Thessaloniki, 24 July 2019
Ref. No: 5165/24.7.2019

**CLARIFICATIONS REGARDING THE OPEN CALL FOR TENDER FOR THE SUPPLY,
INSTALLATION & DELIVERY IN FULL OPERATION
OF LED LUMINAIRES IN TWENTY-NINE (29) LIGHTING MASTS OF THPA SA**

Mounting

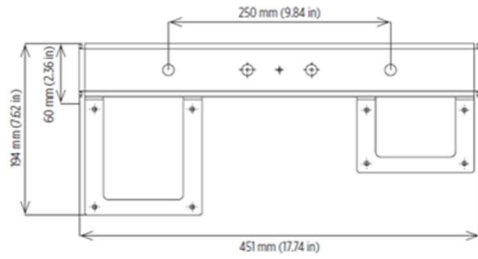
Can you please also check if you would need the pipe mount kit to install the fixtures on the pole or if would be possible to mount directly with the bracket as shown on the drawing bellow?

The bidder is responsible to provide all the required materials for the proper installation of the fixtures. The pillars (masts) are typical for ports (high ~35m), equipped with fixtures mounting hoop.
